## **1. Opening remarks and introductions**

The Chairman, Don Tolmie of Los Alamos National Laboratory, opened this HIPPI-6400 meeting and thanked Chris Olson and Lockheed Martin for hosting this meeting. This group is constituted as both the HIPPI special working group (SWG) under X3T11, and the HIPPI Networking Forum (HNF) - Technical Committee (TC).

##### **4.1 HIPPI-6400-PH, Rev 0.9**

### **5.1.3 Jackscrew connector**

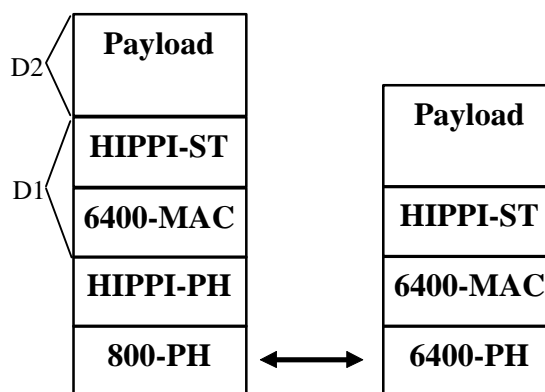
John Ellis of Berg brought in a jackscrew version of the Micropax 100-pin connector. The jackscrew configuration allows a connector to have a 45 degree exit from the bulkhead. The 45 degree exit angle allows companies to meet requirements for separation between the bulkhead and the cabinet back (E-Systems quoted a requirement of eight inches.) Craig Davidson moved, and Hansel Collins seconded, to use a connector with jackscrews. Motion passed, 9 for, 0 opposed, and 3 abstentions.
